Agenda Item # 17

SUB-SW-003761-2026

- Request to waive the construction of 284 feet of sidewalk along 7th Avenue.

APPLICATION NUMBER 17 DATE July 16, 2026
 APPLICANT Anthony T. Fadalla (Byrd Surveying, Inc., Agent)
 REQUEST Sidewalk Waiver

SITE PLAN

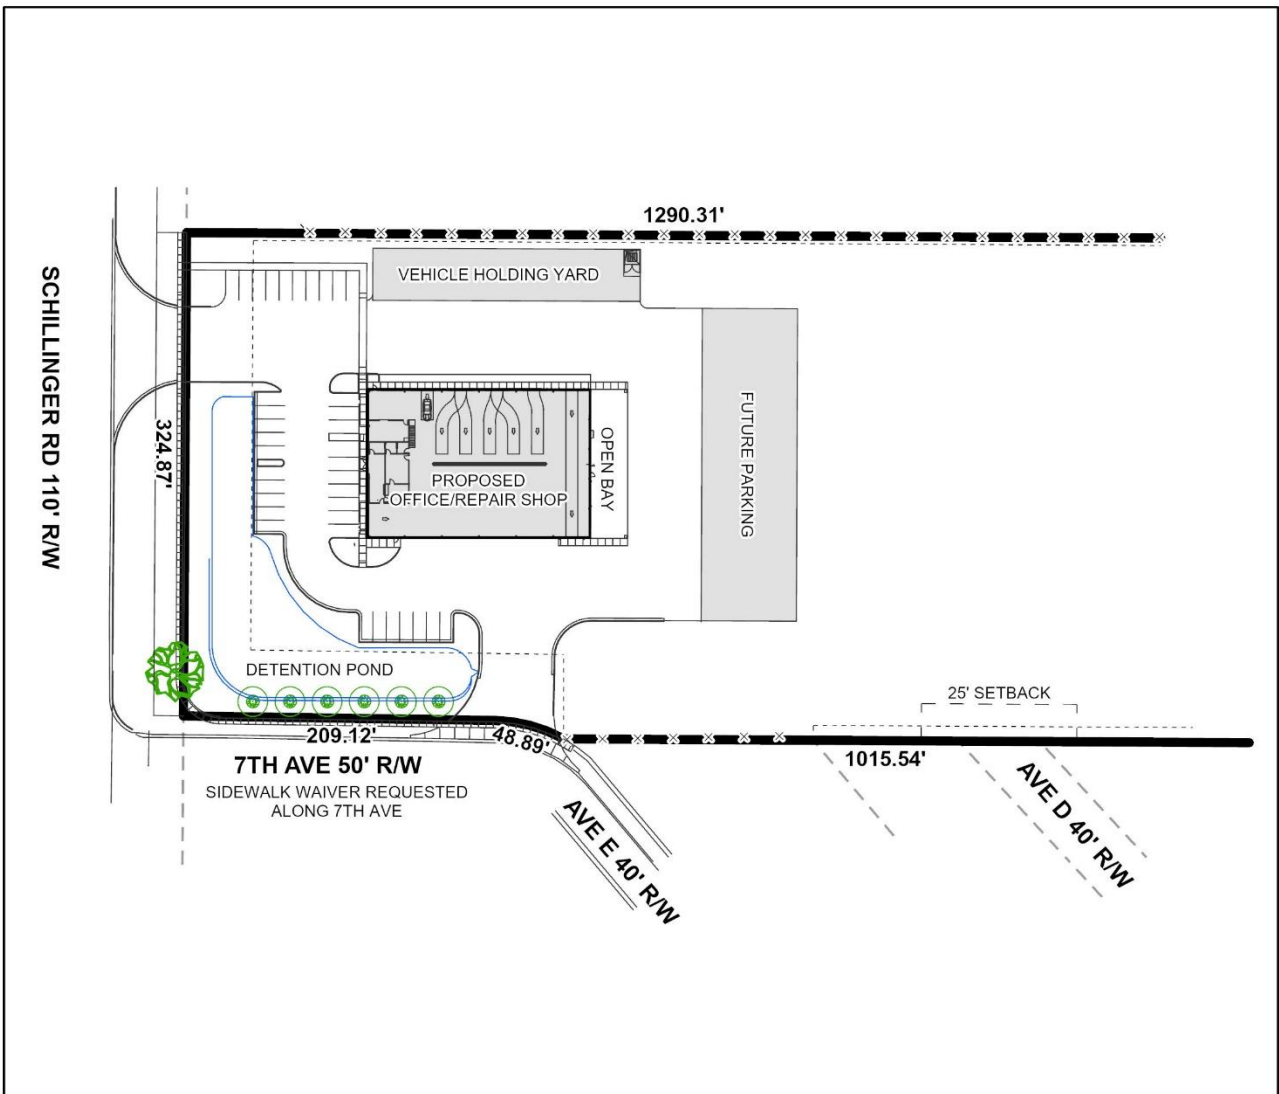
It appears that there is sufficient room within the ROW, or within the property, for the construction of a sidewalk that could be approved through the ROW Permit process.

Pursuant to Section 7.C.4. of the Subdivision Regulations, sidewalks are required along the site's frontage on Schillinger Road North and 7th Avenue. The applicant has requested a waiver from this requirement along 7th Avenue, citing the following justifications:

1. **Limited Space.** There is limited space along 7th Avenue to accommodate a sidewalk due to existing utilities.
2. **Utilities and open ditch.** At the corner of Schillinger Road North and 7th Avenue there is an existing gas line marker, telephone pedestal, and an AT&T fiber optic cable box.

The applicant has submitted a site plan illustrating the proposed development. All application materials are available for review via the link provided on Page 1 of this report.
